SERVICE BULLETIN

1991 LEGACY LS S/W

09-25-91

SUBJECT: WEAK/NOISY AM RADIO RECEPTION, WHEN RECEIVING DISTANT STATIONS

**Antenna Grounding
Figure 1**

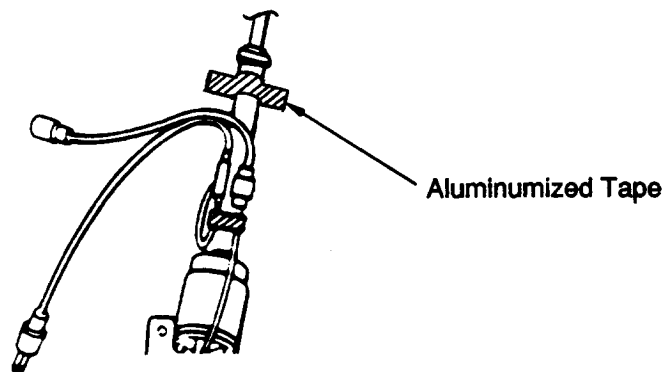
1. To ensure proper grounding of the antenna mounting hardware, the following steps should be carefully observed. See Figure 1.
 - a. Remove the pocket from the right rear interior quarter trim to gain access to the power antenna assembly.
 - b. Remove the screws securing the antenna mounting plate to the body and polish all areas of contact between the mounting plate and body.
 - c. Apply aluminized tape to the antenna base as shown in Figure 1.
 - d. Clean all areas where tape touches antenna and body, to ensure firm contact.

**Antenna Feeder Cable Routing
Figure 2**

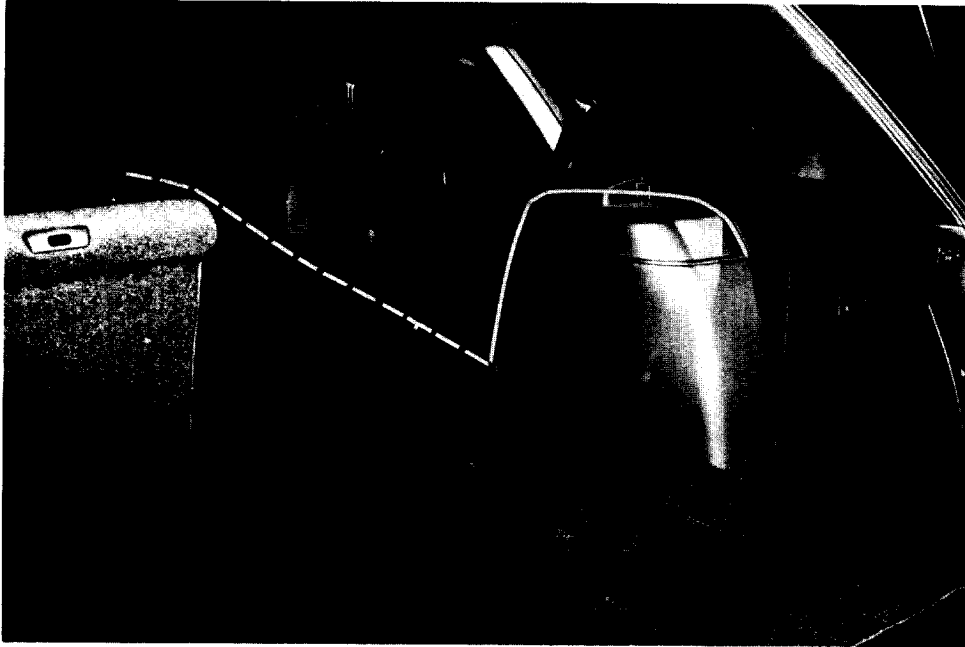
2. Remove the right strut tower cover and disconnect the antenna feeder cable from the antenna assembly.

Put the rear seat and back rest in the cargo position and remove the original feeder cable. Route the new cable as illustrated in Figure 2.
